**From:** Stephen Vereker [REDACTED]  
**Sent:** Monday, 31 August 2020 10:35 PM  
**To:** Rod Davison; Info  
**Cc:** Ana Mitrov; G&S Vereker  
**Subject:** Re: Response to C91 Amendment - Moorabool Shire (Moorabool Planning Scheme Amendment C91 - Flood overlays)

Further to communications re Amendment C91, please find below our response.

**Re: Submission to Amendment C91**

# MOORABOOL PLANNING SCHEME - LOCAL PROVISION AMENDMENT C91moor

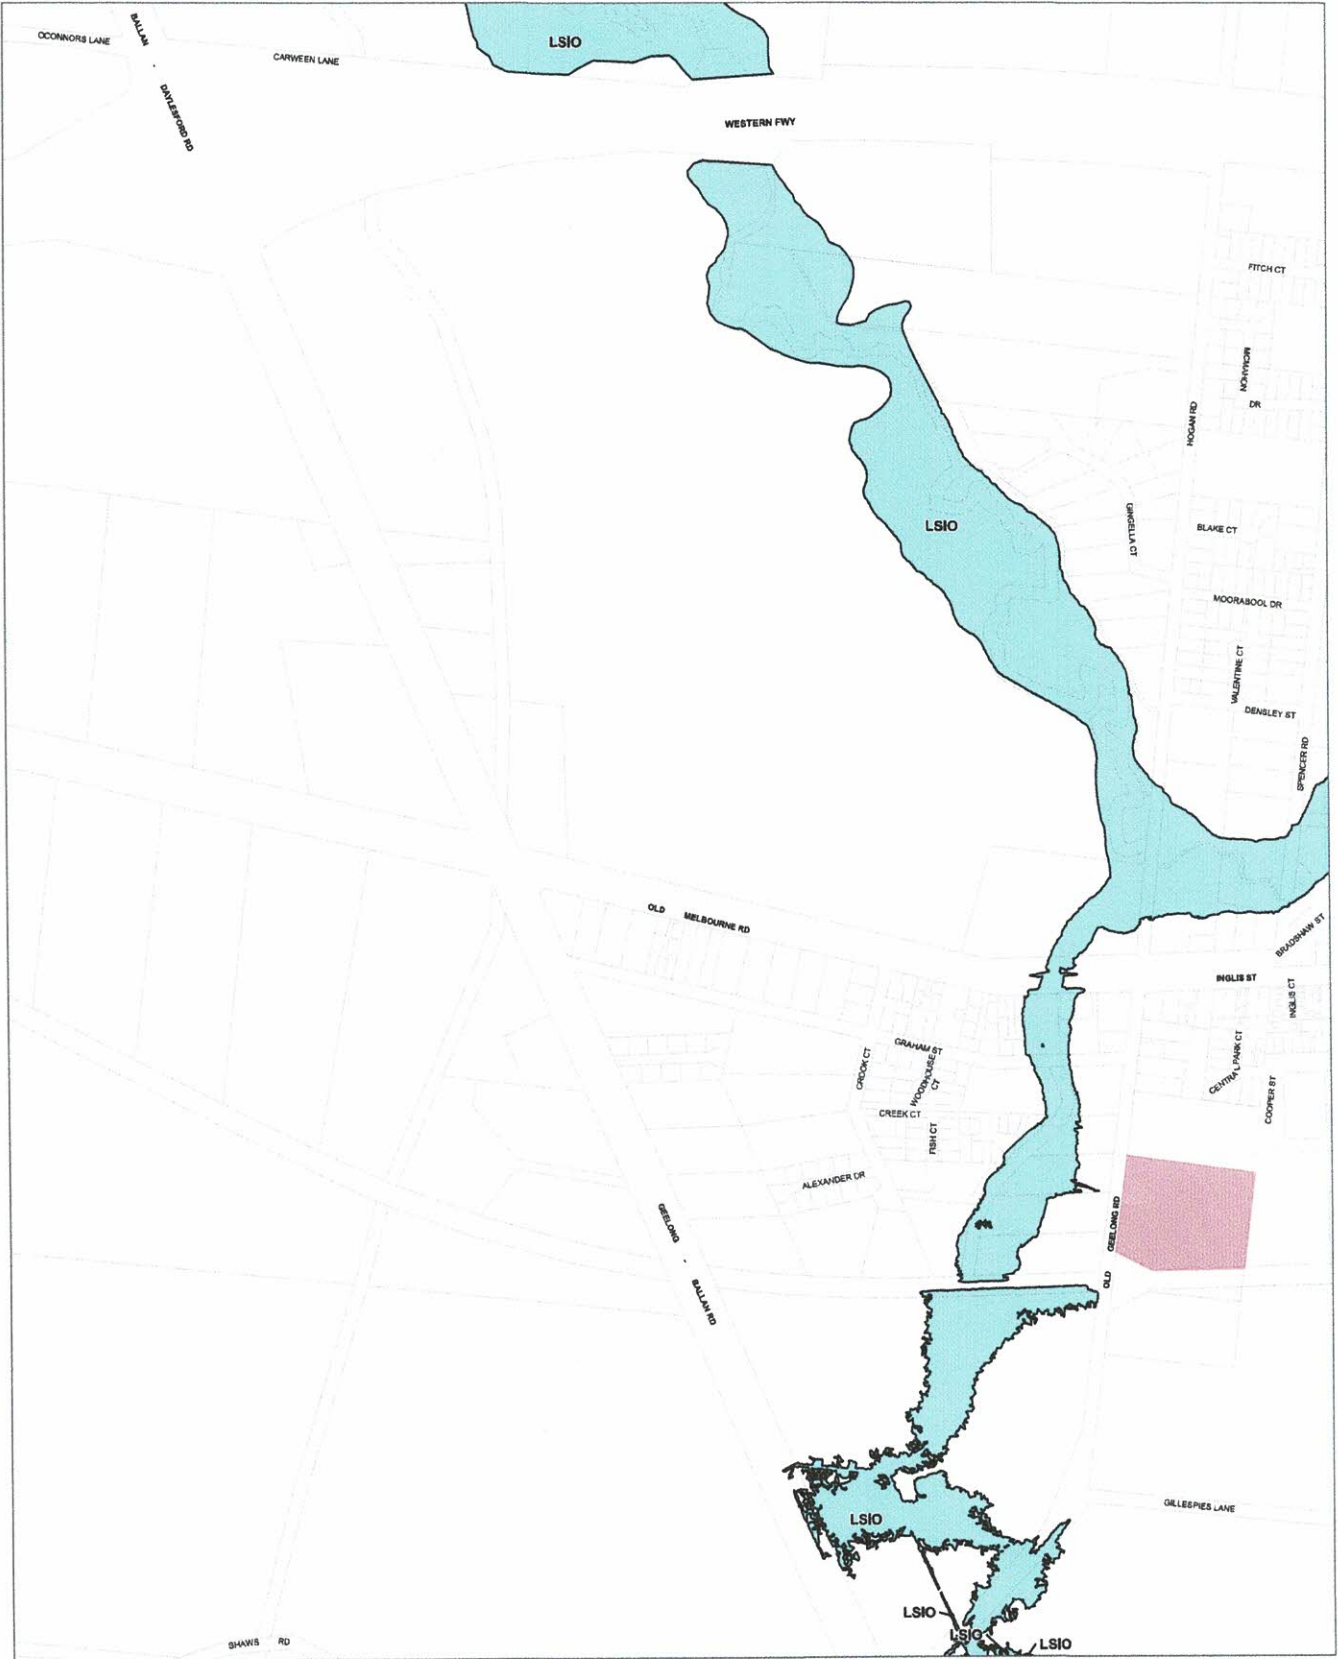
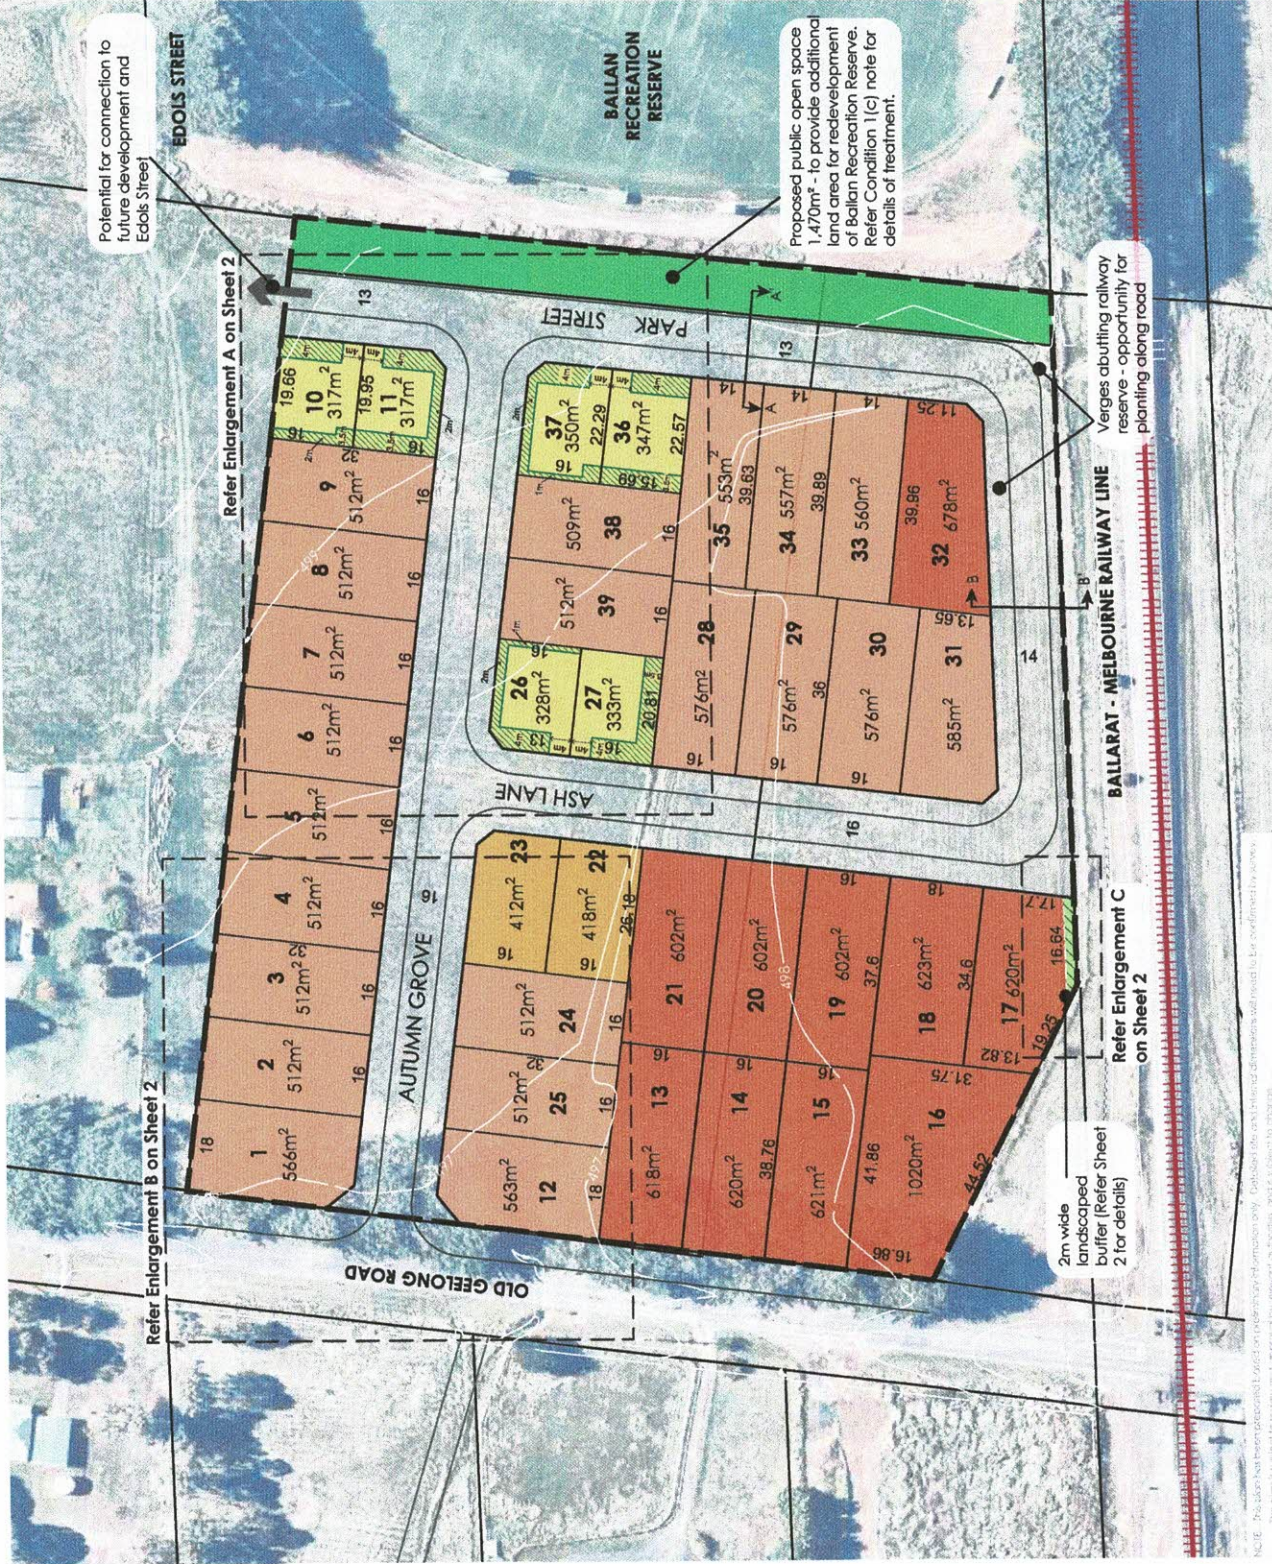
As indicated in the attached C91 plans the land does not have an LSIO but does have a SBO over a small part.

Whilst the boundary of the overlay appears random it largely follows the alignment of an existing open drain which drains both our land and the broader drainage catchment to the south of the railway line. This drain is indicated on the attached feature survey plan.

It can be seen from the attached plan indicating the subdivision layout over the feature survey plan that the SBO will impact parts of some of the proposed allotments.

The primary purpose of our submission is to invite Council to consider the inclusion of a “sunset clause” in relation to the SBO on our land.

If it can be achieved within the scope of the amendment we would request that Council insert a provision that the SBO cease to have effect on the registration of the plan at the Titles Office.

In situations such as this, Melbourne Water's advice is as follows:

- Following future completion of approved drainage works, the proponent would need to prepare 'as constructed plans' and certified survey plans for the works.
- The proponent should then review the SBO extent in consultation with Melbourne Water.
- A future planning scheme amendment would then be required to implement any reduced SBO extent. Subject to Melbourne Water's agreement, this could potentially be done as a proponent initiated amendment, under section 20(4) of the *Planning and Environment Act 1987*.
